Development Plan Public Realm Report

DELEGATE REPORT

MINISTERIAL PLANNING REFERRAL

Application number:	TPM-2019-26
DELWP Application number:	SP070004
Applicant / Owner / Architect:	Ashe Morgan Pty Ltd / Development Victoria / NH Architecture
Address:	50-94 Waterfront Way and 2-16 Little Docklands Drive, Docklands VIC 3008
Proposal:	Addendum to the Waterfront City Outline Development Plan 2003
Cost of works:	N/A
Date received by City of Melbourne:	Original Proposal: 26 September 2019 Current Proposal: 24 March 2021
Responsible officer:	Markus Tschech, Principal Urban Planner

Figure 34 – Wind mitigation measures required as part of the original proposal

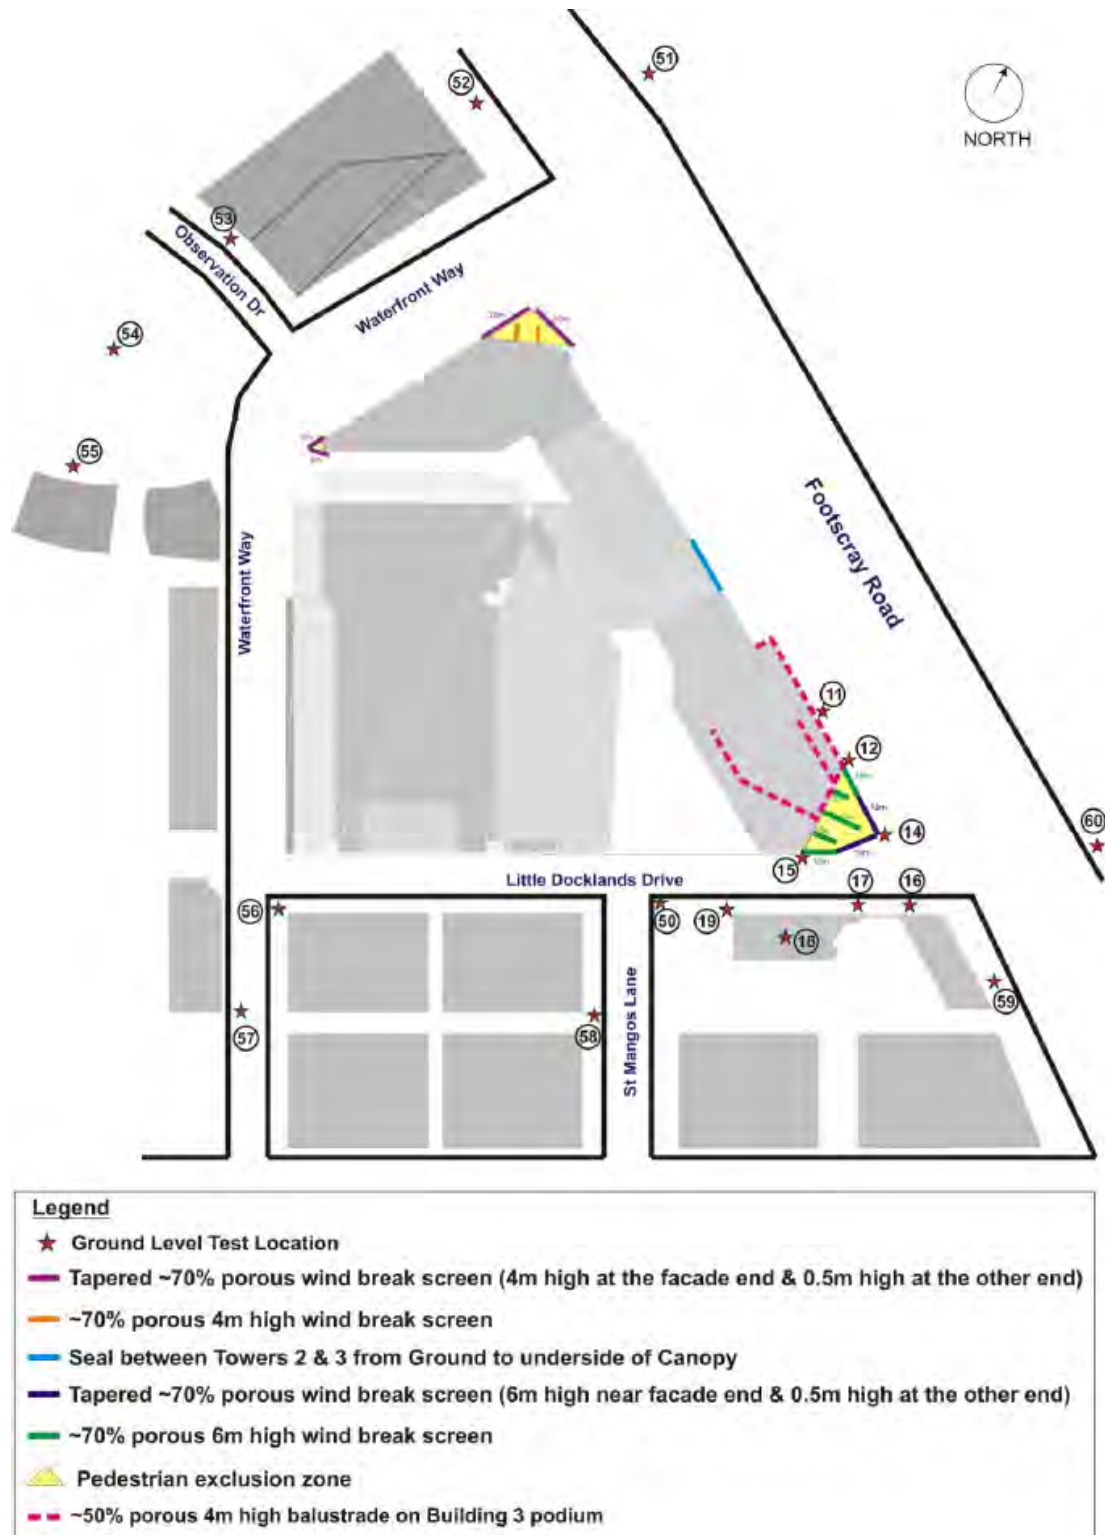
Although there are extensive mitigation measures shown at ground level, the report prepared for the original proposal required extensive ground level 'pedestrian exclusion zones' which were apparently sometimes unsafe for occupation (refer to Figure 34).

Figure 345 - Concept Plan 23 - Movement and Parking Plan 1 - Ground Floor pedestrian paths and access points

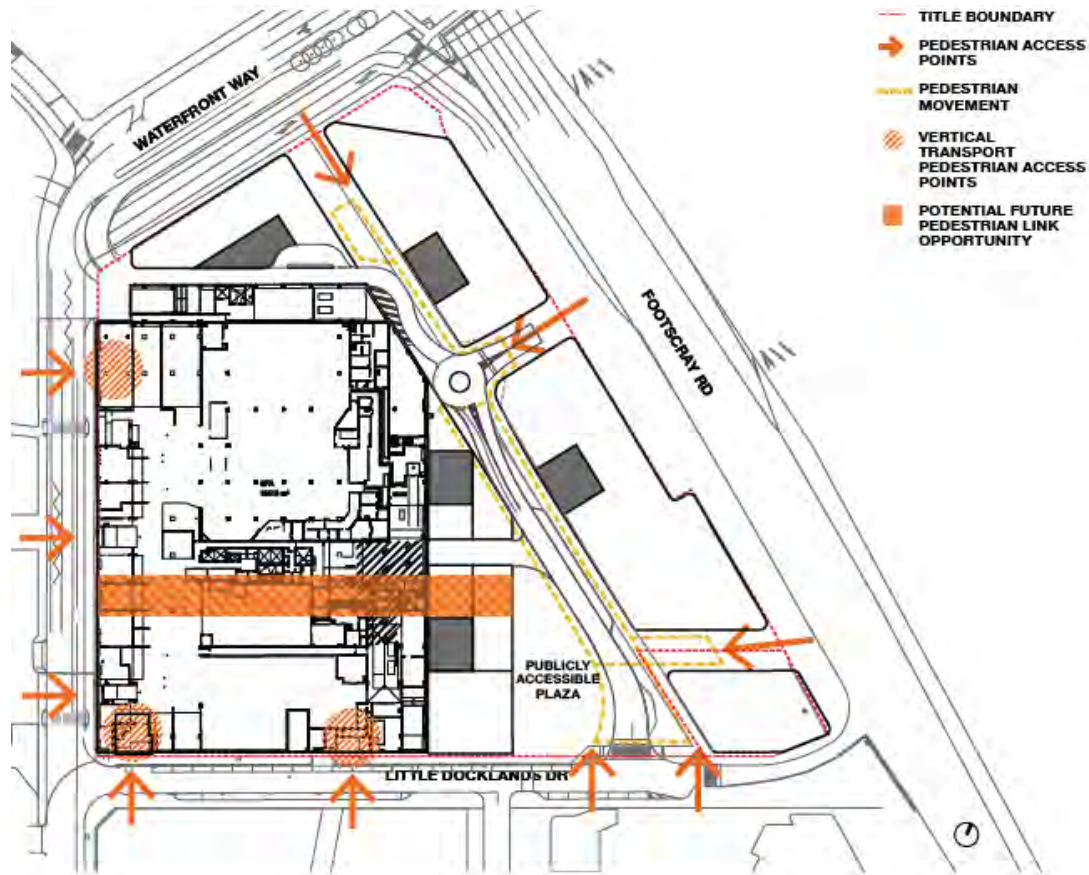
As illustrated in figure 35, the revised DP Addendum now allows for pedestrian movement through the site at ground level, with two access points along Footscray Road and one each along Waterfront Way and Little Docklands Drive.

The revised pedestrian connections are therefore considered to be acceptable.

Figure 356 - Vehicle access according to DP Addendum Movement & Parking Plan 4

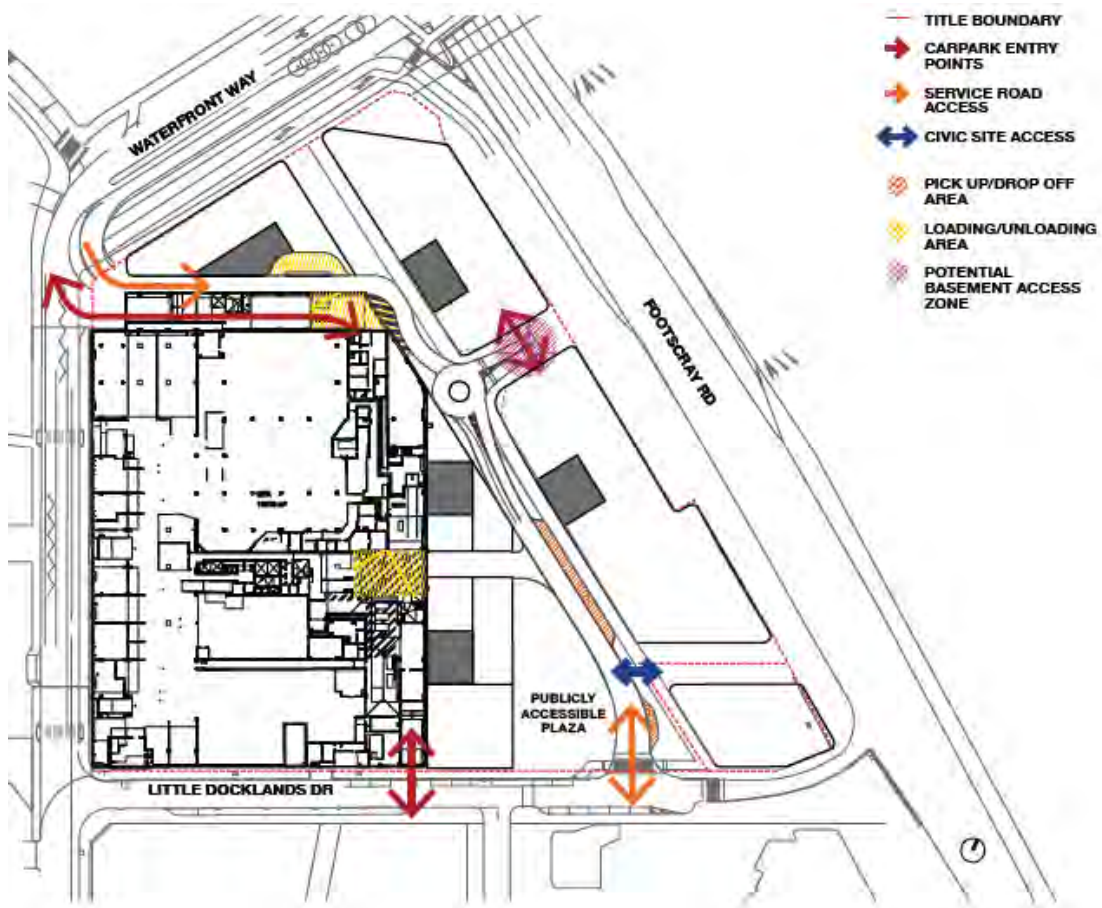
As illustrated in Figure 36, vehicle access to and from the site is via crossovers to Little Docklands Drive and Waterfront Way. Vehicle access and circulation requirements remain largely unchanged from the original proposal.

The conditions suggested by Council's Traffic Engineer will form part of the recommended conditions to DELWP.

Figure 367 - Proposed staging from the DP Addendum

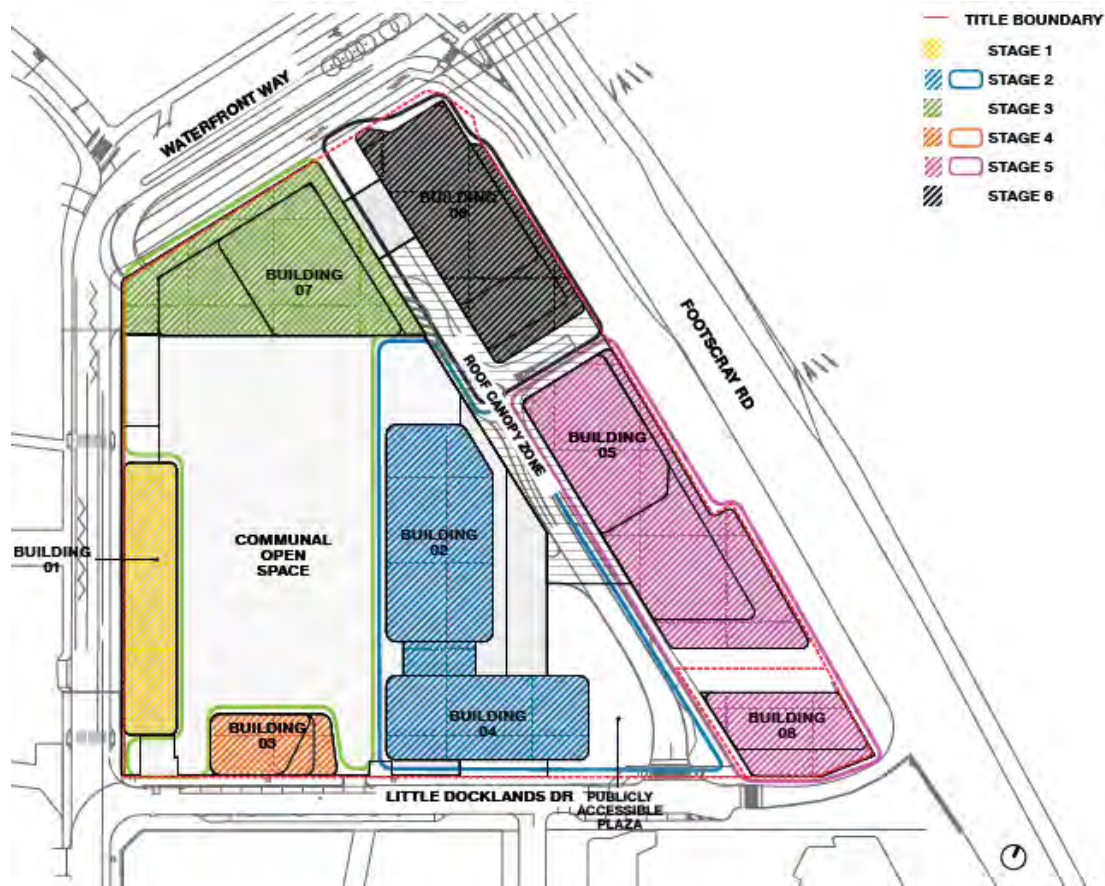
The staging diagram shown in the DP Addendum (refer to Figure 37) starts by developing Building 1 (which is likely to commence in early 2022), followed by other buildings on the western side of the internal road. Buildings 5 and 8 would be the first built on the eastern side of the road, with the tallest building (Building 6) built last.

To avoid any such issues, this section of the road must be built as part of stage 3 to allow for the proper functioning of the site. This matter can easily be addressed via a recommended condition.

8. Figure 28 (Staging Diagram) updated to:
 - a. Adopt the same building numbers as the remainder of the DP Addendum.
 - b. Incorporate the remainder of the internal road into stage 3.

Figure 38 - Concept Plan 11 - Canopy Plan

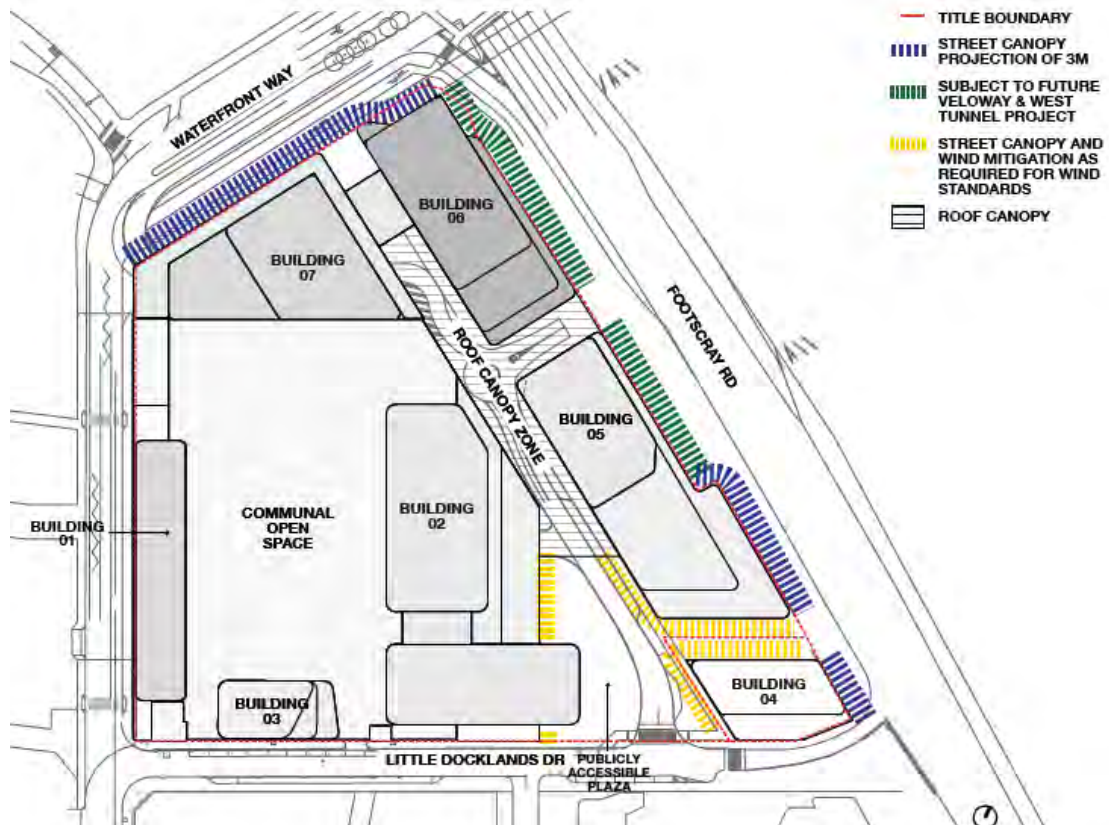
Section 4.9 (Weather Protection) of the DP Addendum requires the provision of canopies of various forms along the street frontages of all buildings that are not directly above the carpark; and the eastern side of Building 4. The Concept Plan (refer to Figure 38) also acknowledges the uncertainties with respect to the final design of the Veloway along Footscray Road.

The proposed extent of canopies is generally consistent with the previous proposal, and is considered appropriate. Importantly, the exact extent and design of canopies / awnings can be resolved at the planning permit application stage.
